ADDENDUM NO. ONE (1)

REHABILITATE RUNWAY 6-24

**ROANOKE-BLACKSBURG AIRPORT
ROANOKE, VIRGINIA**

**AIP PROJECT NO. 3-51-0045-PENDING
DELTA PROJECT NO. 24072**

REHABILITATE RUNWAY 6-24		AIP NO. 3-51-0045-074-2025	JOB NO. 24072
GRADING & DRAINAGE ALTERNATE 2		DRAWN BY: RAS	SHEET 27A
ROANOKE-BLACKSBURG REGIONAL AIRPORT		DESIGNED BY: WME/SRS	OF 58
SCALE: 1" = 40'	DATE: MAY 2026

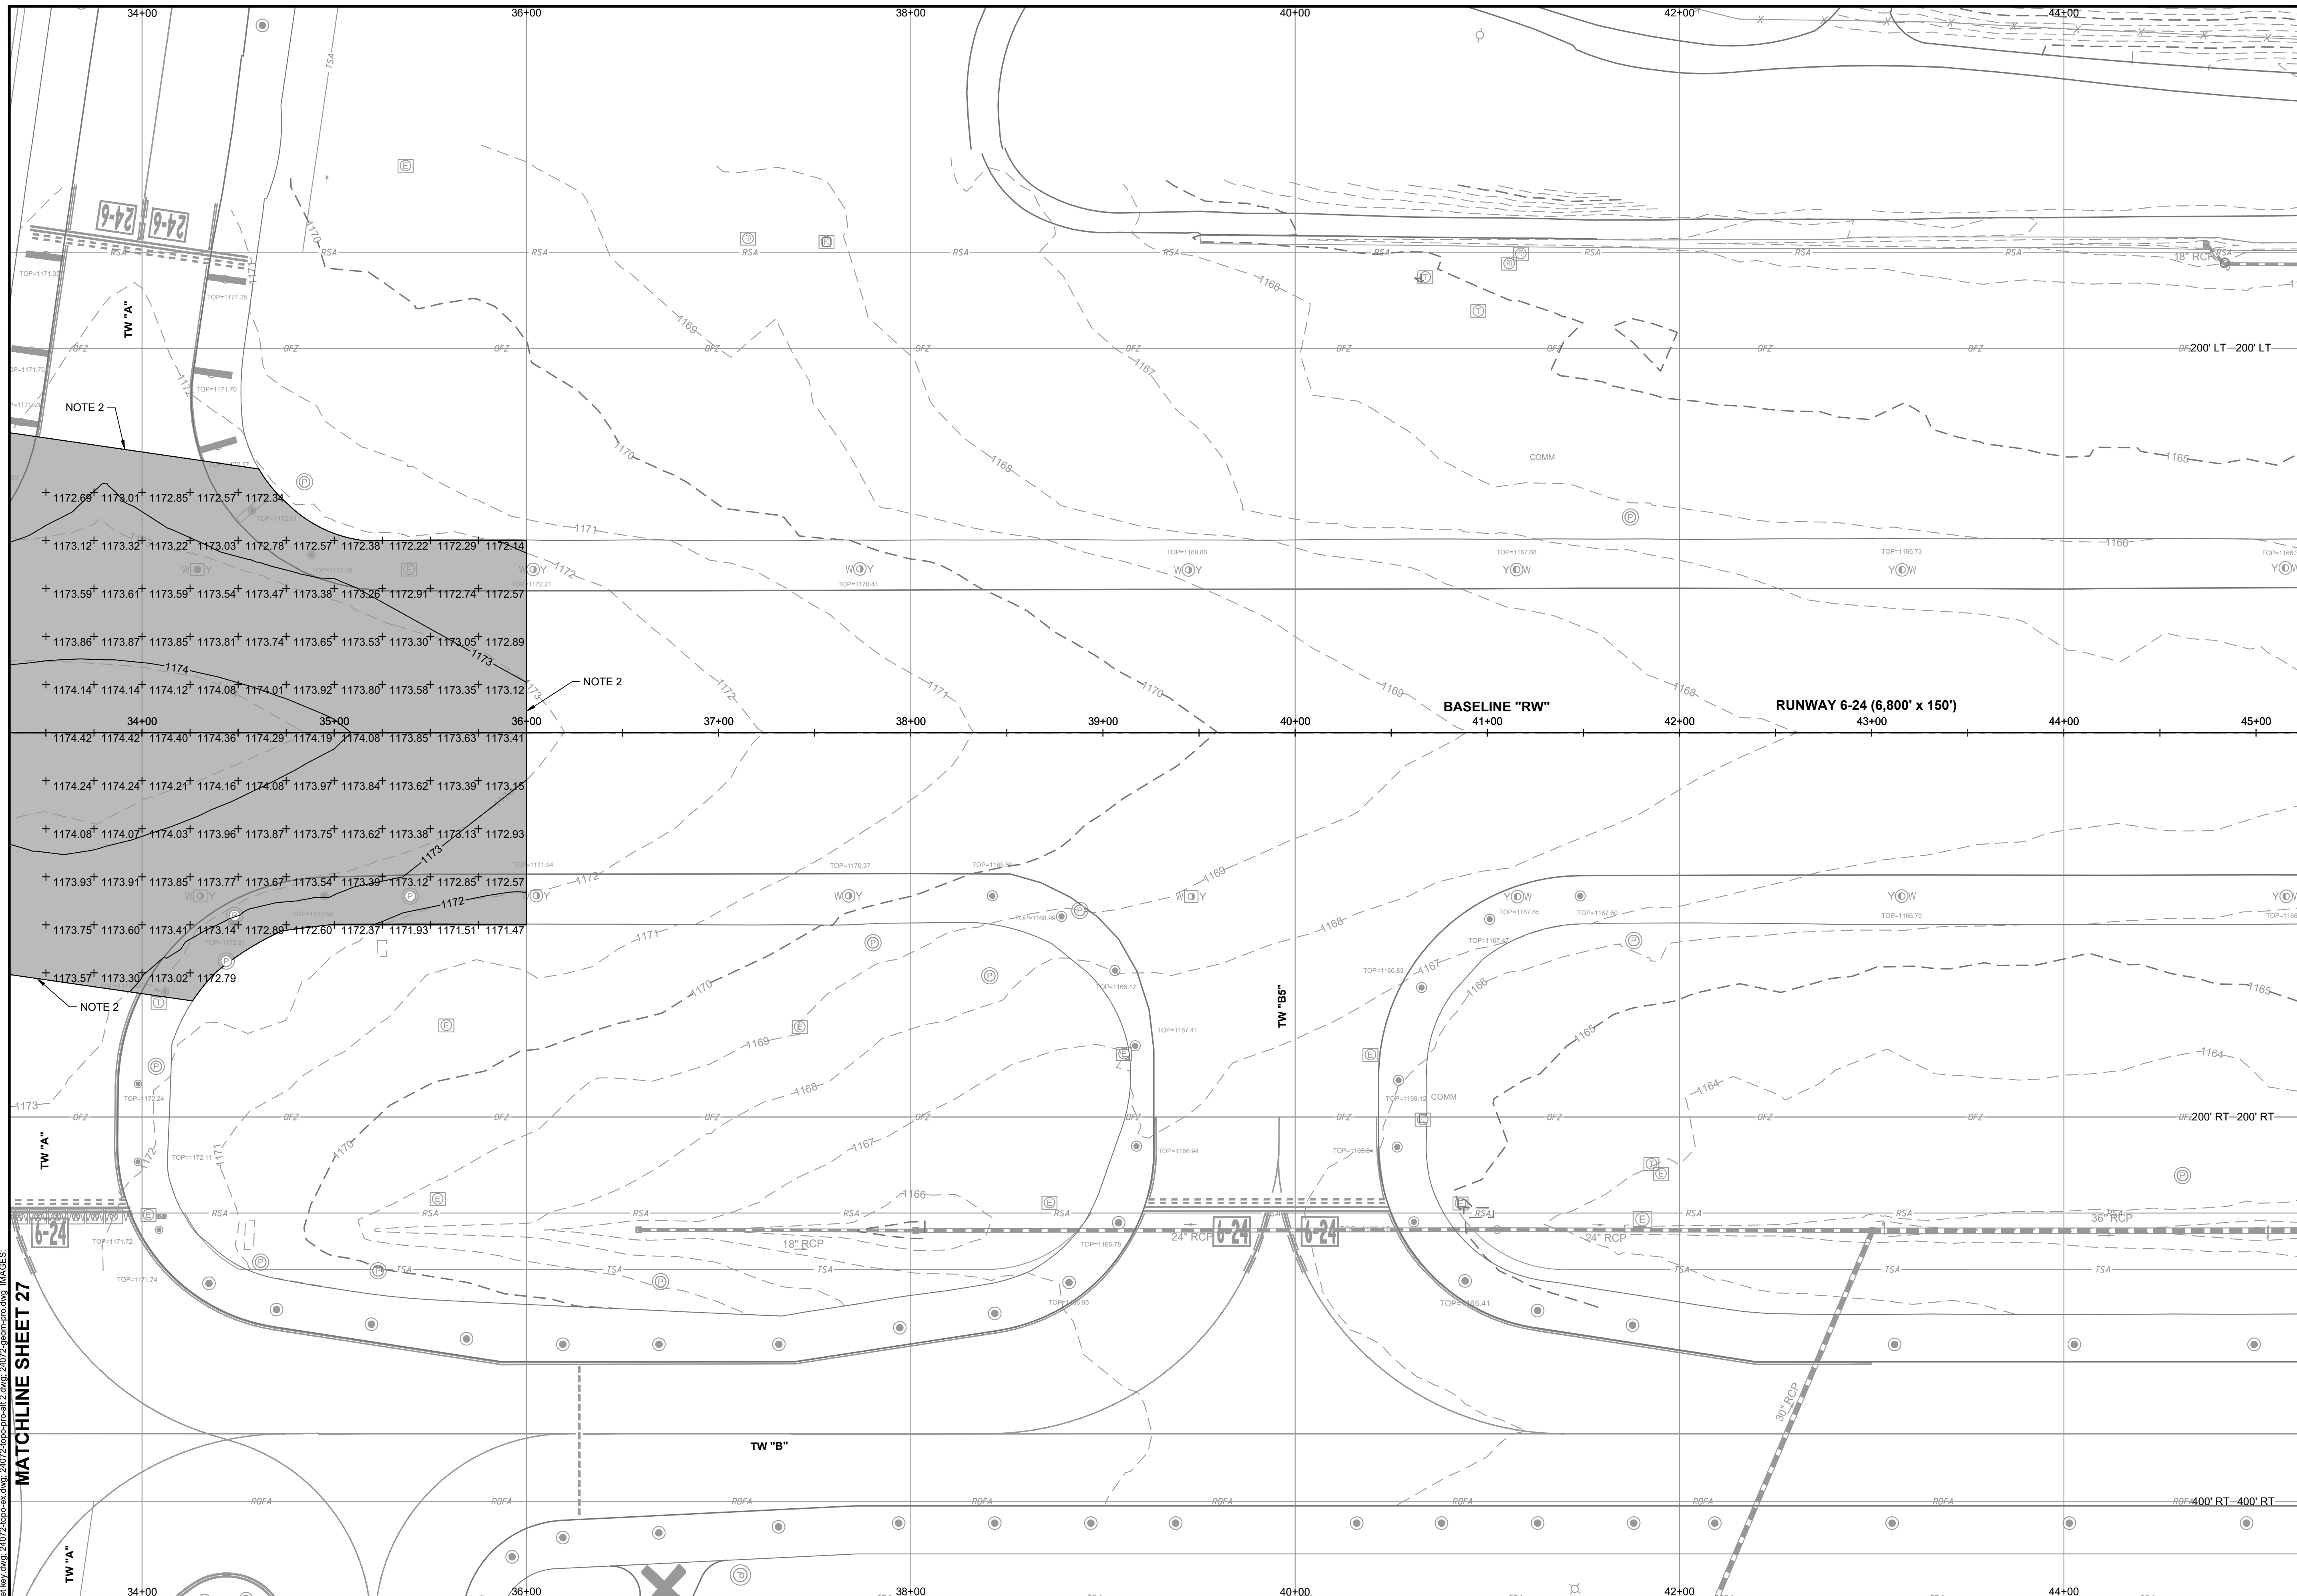
1. **REVISE** Note 2 on Sheet No. 1 to read "ALTERNATE 2 SCOPE INCLUDES ALL WORK SHOWN IN THE PLANS FROM BASELINE "RW 16-34" STA 9+00 TO STA 36+00 UNLESS OTHERWISE NOTED."
2. **REPLACE** Sheet No. 27 with the attached Sheet No. 27.
3. **ADD** Sheet No. 27A of Addendum No. One (1).
4. **REVISE** the Alternate 2 limits so that it extends to Station 36+00 on Sheet No. 2 and 4.
5. **REVISE** the Alternate 1 Only and Alternate 1 & 2 break line from Station 33+18 to Station 36+00 on Sheet No. 10 and 16.
